6 July 2017

**SECTION 4.55 (1A) MODIFICATION APPLICATION – STATE SIGNIFICANT DEVELOPMENT APPLICATION
SSD 6952
WENONA SCHOOL**

Figure 1 Proposed works to the Judith Dey Elevation

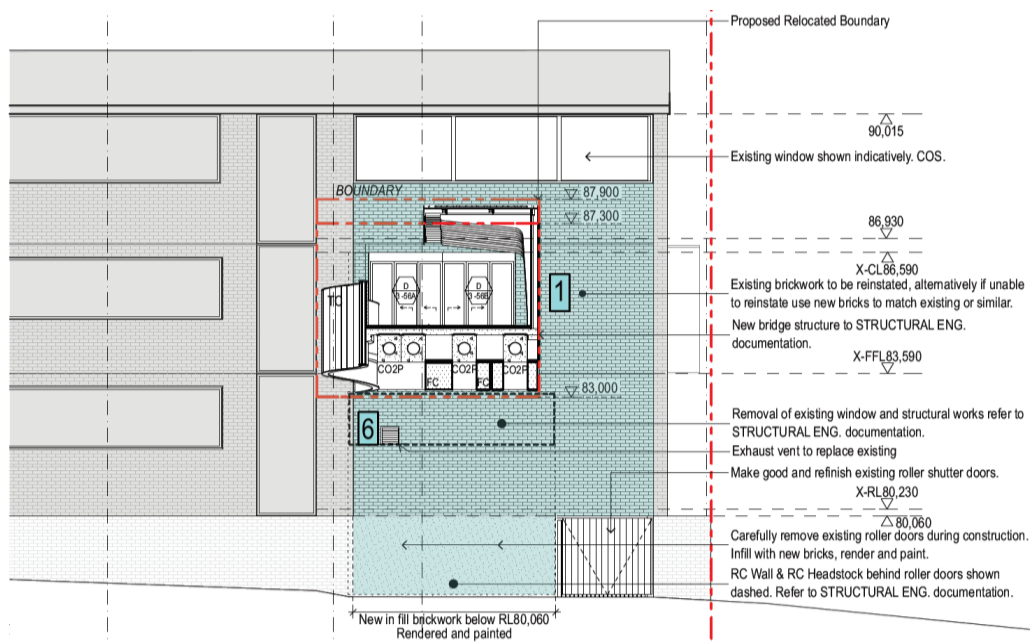
Make-good works to the western elevation of the Judith Dey Wing fronting Elliot Street are required following the removal of the overpass bridge and are detailed in **Figure 1**. The works comprise the infill of the façade through the reinstatement of existing brick work. Where existing brick work cannot be utilised, new brick work consistent with the existing materiality of the façade will be included.

At street level the now redundant roller shutter doors will be removed and infilled with new brick work, render and paint. The roller door located at the southern end of the building will be retained and refurbished (refer to **Figure 1**).

Figure 3 Proposed Elliot Street elevation inclusive of electronic gates

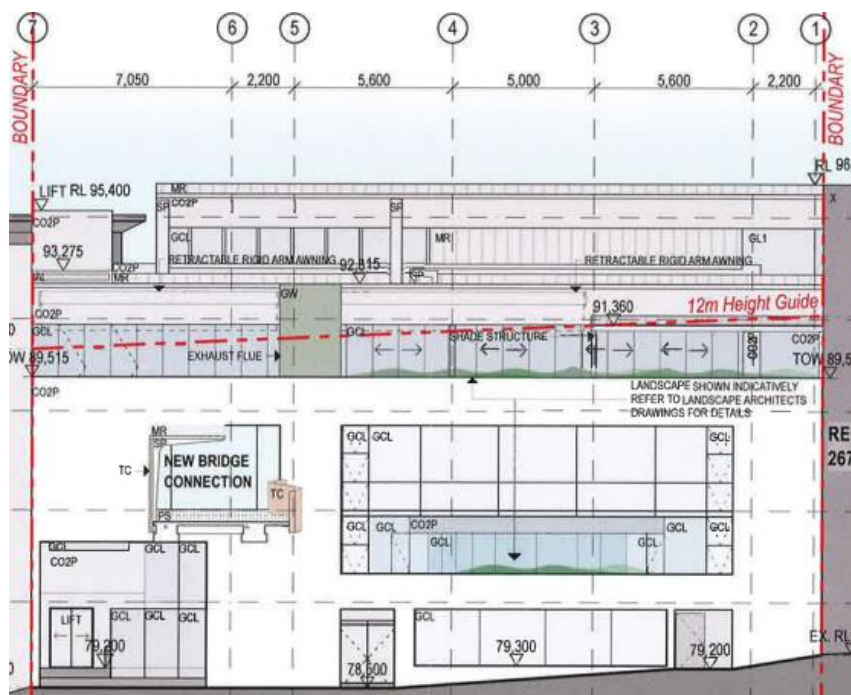
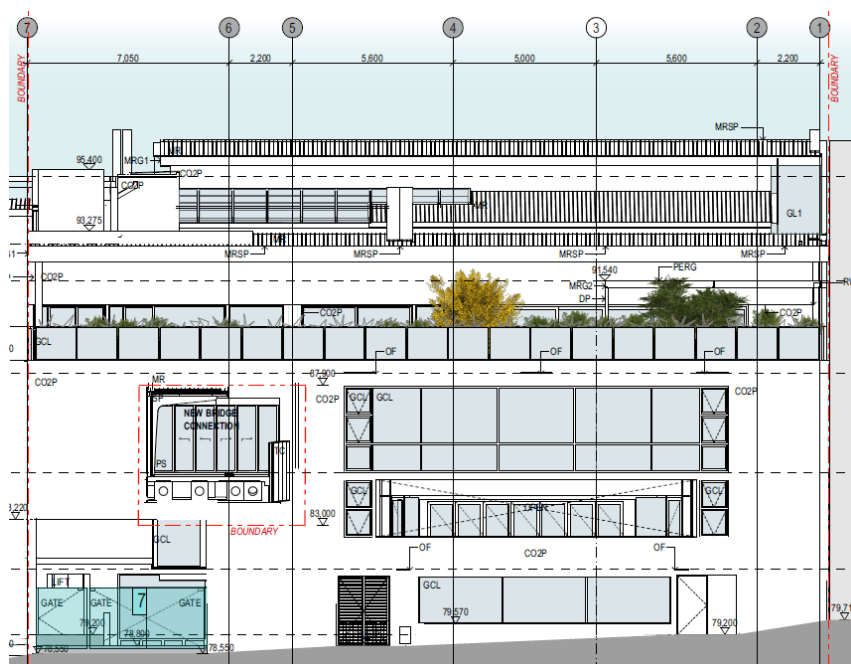
The proposed amendments include the addition of three electronic entrance gates at the building's western elevation fronting Elliot Street. The gates reach a height of 2.1m. Their location and configuration relative to the approved design are shown below in **Figures 2 – 3**.

Figure 4 Approved landscape design (left) and proposed inclusive of grease arrestor pits (right)

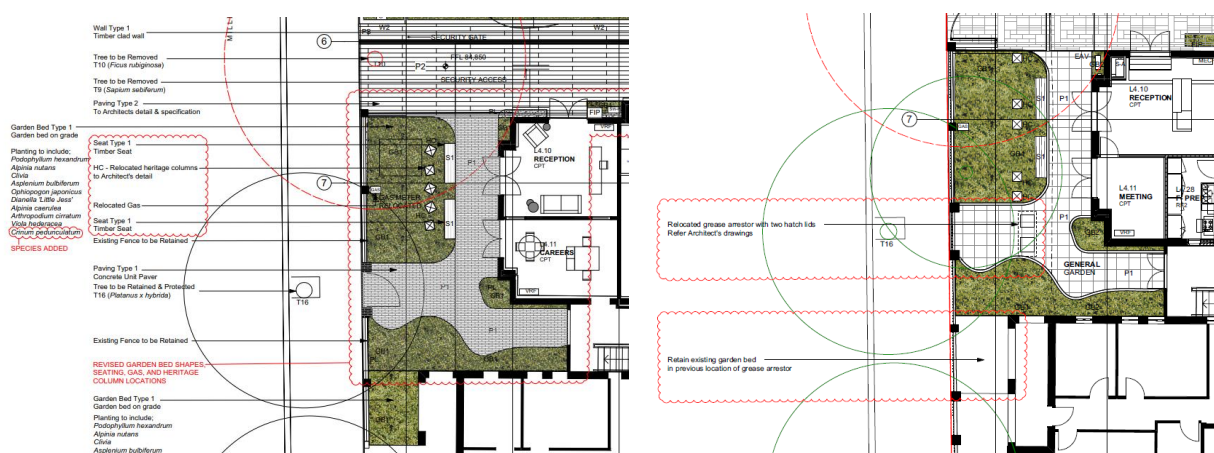
The proposed modifications relate to minor amendments to the landscaping along the Miller Street frontage and the Level 3 terrace. As shown in **Figure 4**, the amendments to the landscape design pertain to the addition of two 600mm diameter access pits. The two pits will service the proposed grease arrestor located approximately 1200mm beneath the ground level.

The modifications are proposed in order to facilitate the relocation of the grease arrestor. The grease arrestor has been relocated to maintain an appropriate curtilage around the heritage listed building at 255 – 257 Miller Street, North Sydney (I10912).

Figure 5 **Approved Level 3 terrace (left) and proposed (right)**

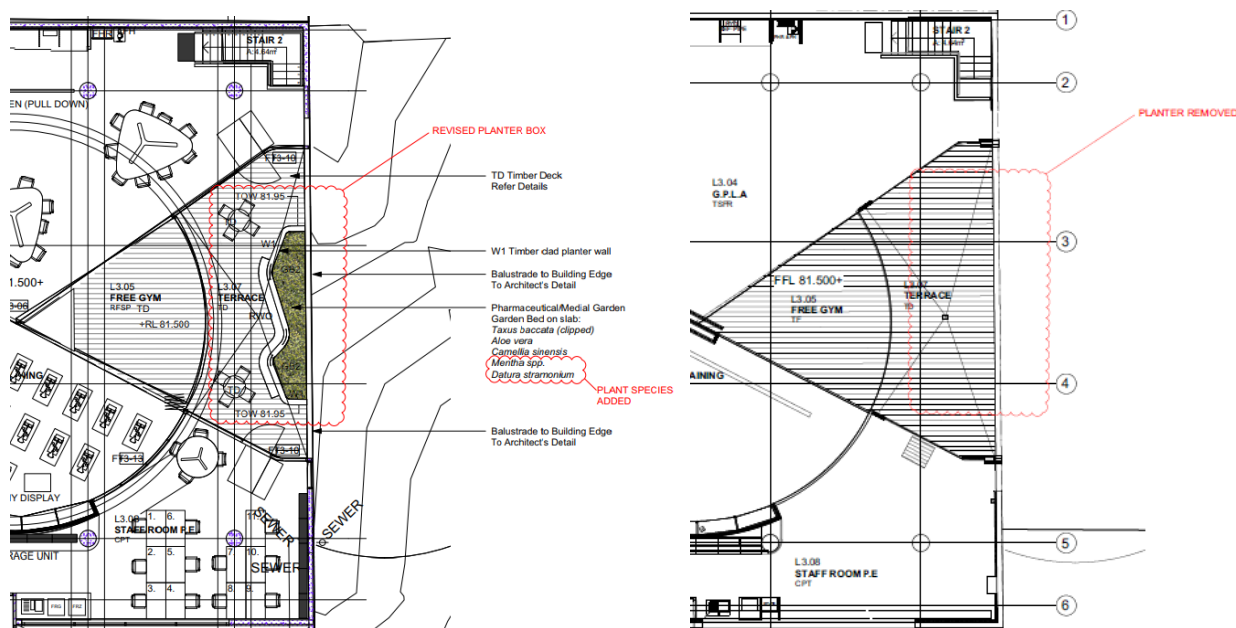
The modifications also relate to the removal of the approved planter box located at Level 3. The removal of the planter box will facilitate the extension of the terrace and will increase the amount of useable space (refer to **Figure 5**).

Figure 6 Proposed wall height shown in red outline

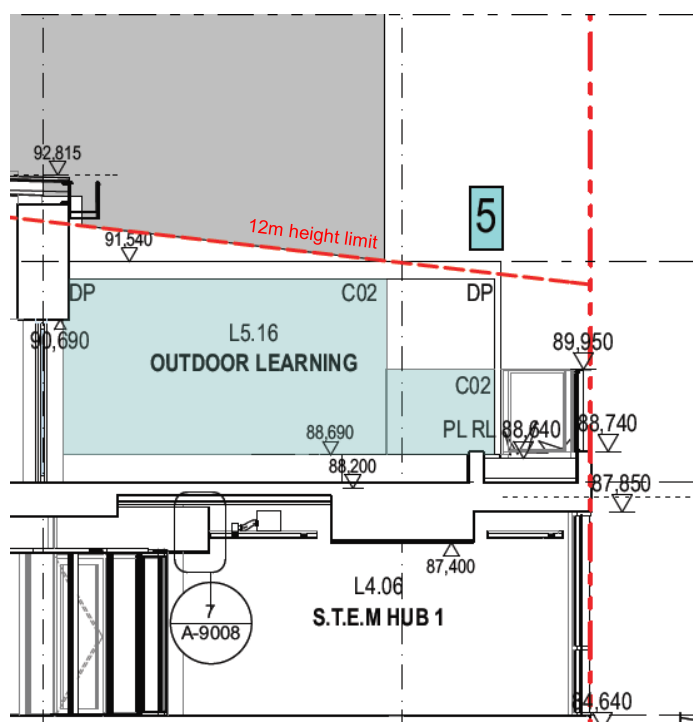
At Level 5, the eastern end of the northern boundary wall is proposed to increase in height from RL 89,860 to RL 89,950 and RL 91,290 (refer to **Figure 6**). The purpose of the revised wall height is to screen the blank wall of the adjoining property to the immediate north to prevent waterproofing issues and improve the appearance of the space.

The minor wall extension, which is proposed to increase from 89,860 RL to 89,950 RL, is located to the immediate south of the existing blank wall of the Regency Park apartment complex, and as such cannot be seen from this development at any angle.

Figure 7 Proposed air supply louvre and window

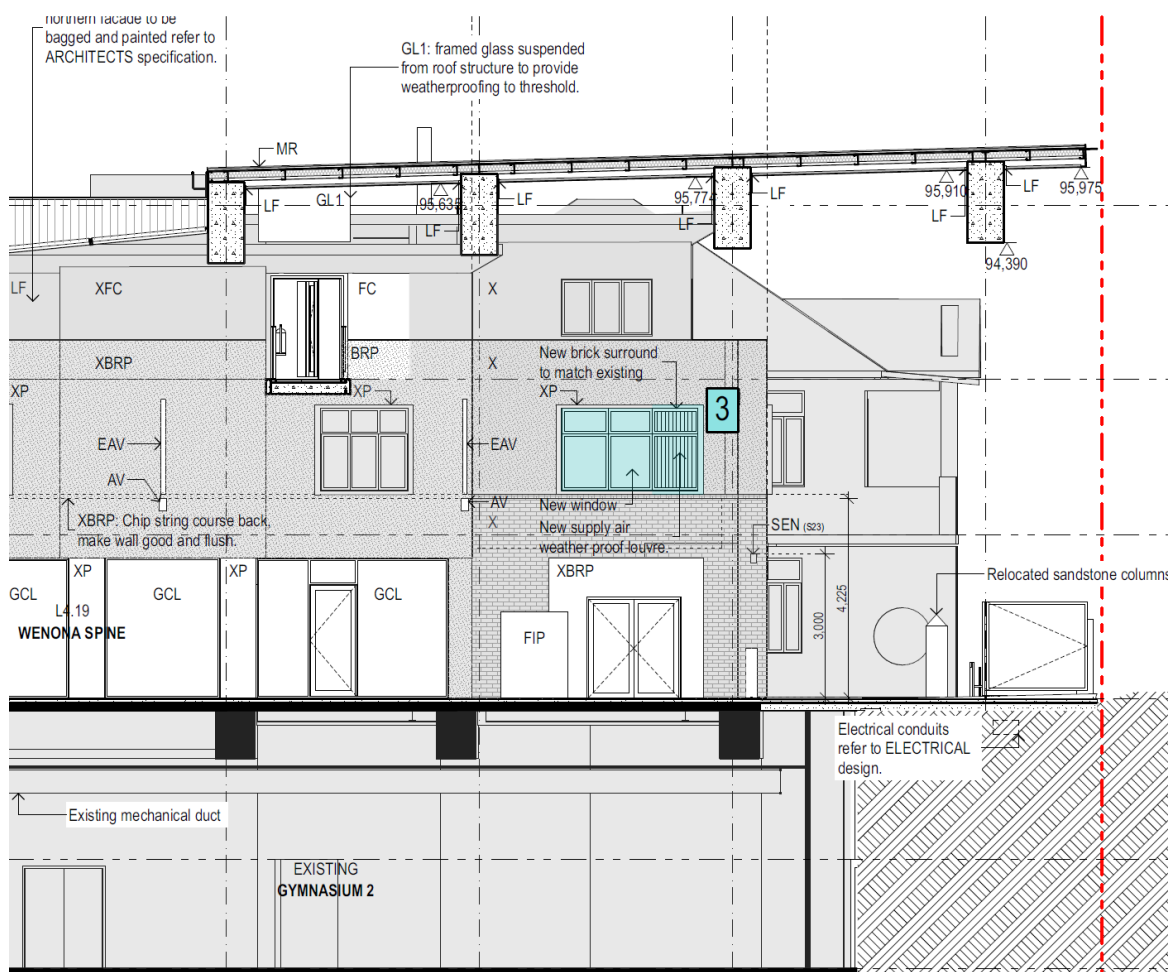
As shown below in **Figure 7**, the proposal includes the addition of an air supply louvre and window along the northern elevation of the Miller Street Campus Building. The louvre and window are necessary due to structural constraints that make the original intake orientation (west facing) impossible. To facilitate the installation of the air supply louvre, brickwork will be included and will match the existing façade.

Figure 8 Approved northern wall height (left) and proposed (right)

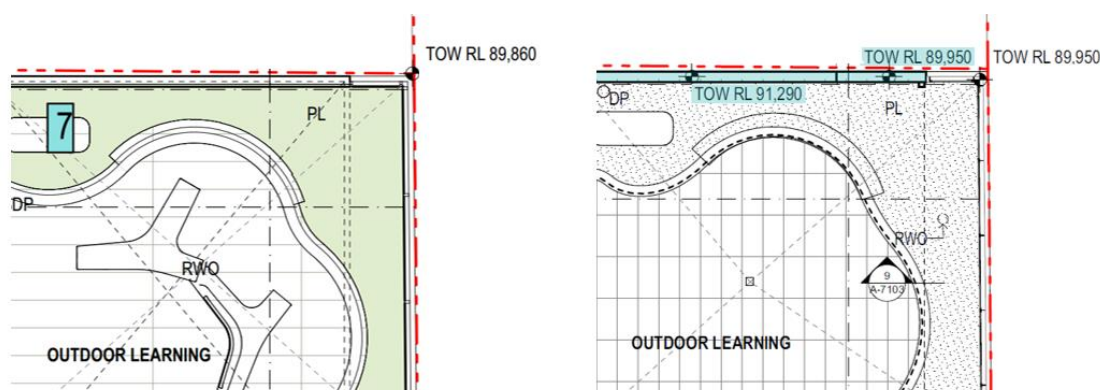
The proposal seeks to increase the height of the eastern end of the northern boundary wall from RL 89,860 to RL 89,950 and RL 91,290, as shown below in **Figure 8**. Notwithstanding the increase to the height of the wall, the building envelope remains within the 12 metre maximum limited nominated by the North Sydney LEP 2013 (refer to **Figure 6**). The increase to the height of the wall is minor and will not be perceptible from the surrounding public domain. The modification will facilitate the delivery of an improved design outcome in that it will screen the ill-finished Regency Park blank wall to the direct north to achieve a higher standard of visual amenity, and will permit appropriate and necessary waterproofing.
